**Report No. 13.18      PLANNING - Development Application 10.2017.516.1 Subdivision to create four (4) lots, removal of trees, earthworks and associated infrastructure - 8 Coomburra Crescent, Ocean Shores**

**DA No:** 10.2017.516.1

**Proposal description:** Subdivision to create four (4) Lots

**Figure 1 – Proposed Plan of Subdivision**

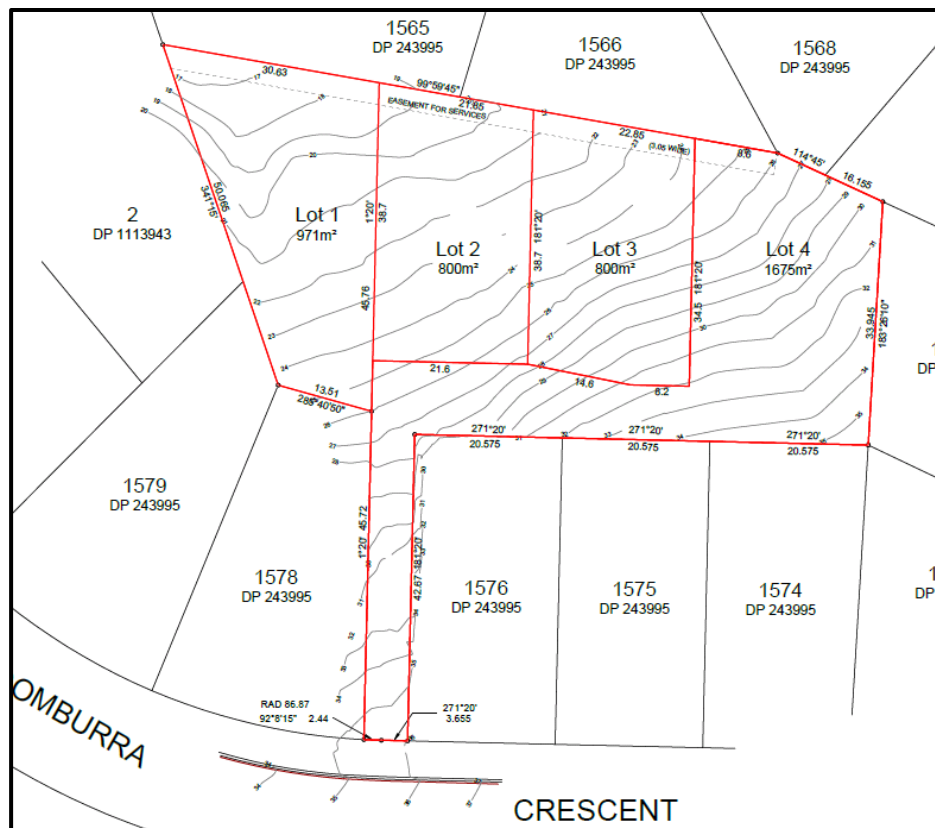
The configuration of the proposed Lots is shown in **Figure 1**. The proposed lots vary in area as follows:

Proposed Lot	Area in m <sup>2</sup>
Lot 1	971
Lot 2	800
Lot 3	800
Lot 4	1675
